**Addendum #1 IFB 21-55**

**To:** Arthur D. Healey School Tot Lot Construction  
**From:** Andrea Caruth, Assistant Director of Purchasing  
**Date:** March 05, 2021  
**Re:** Changes to specifications and responses to questions

ARTHUR D. HEALEY TOT-LOT RENOVATION

SKL-AD1-002: 4/L400 - PIP RUBBER SURFACING

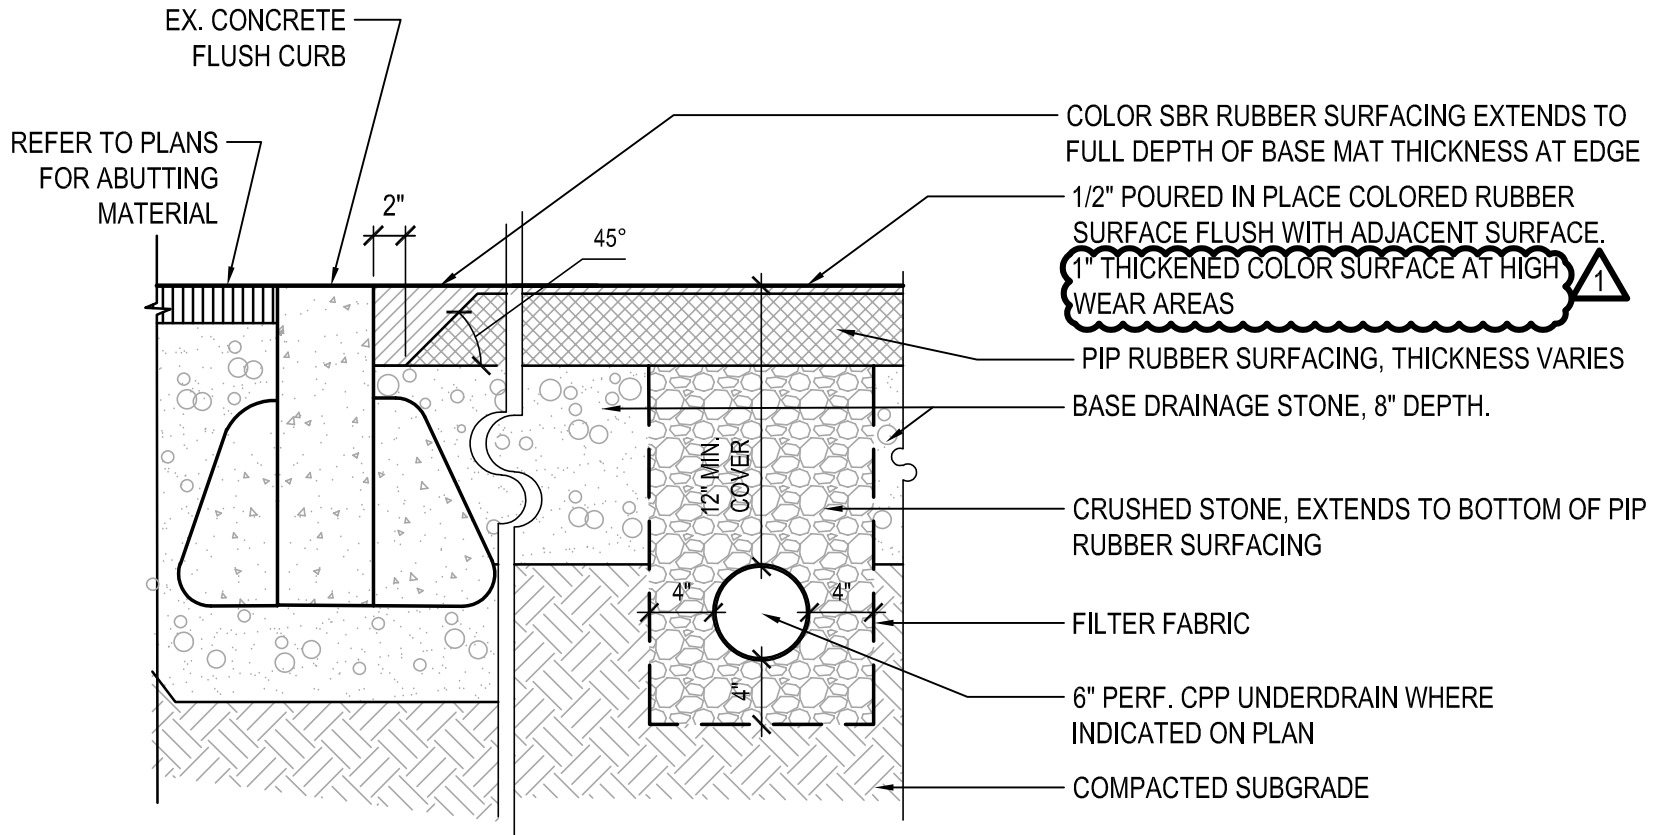
1. RUBBER BASE MAT THICKNESS VARIES.
2. MUST MEET CPSC SAFETY REQUIREMENTS.
3. PIP EDGE TO SLOPE DOWN TO SUBGRADE WHERE NO CURB/EDGE IS SHOWN ON PLAN.
4. 1" THICKENED COLOR SURFACE AT HIGH WEAR AREAS (BELOW SWINGS AND EXIT OF SLIDE). MIN. AREA TO BE 4'X4'. 1
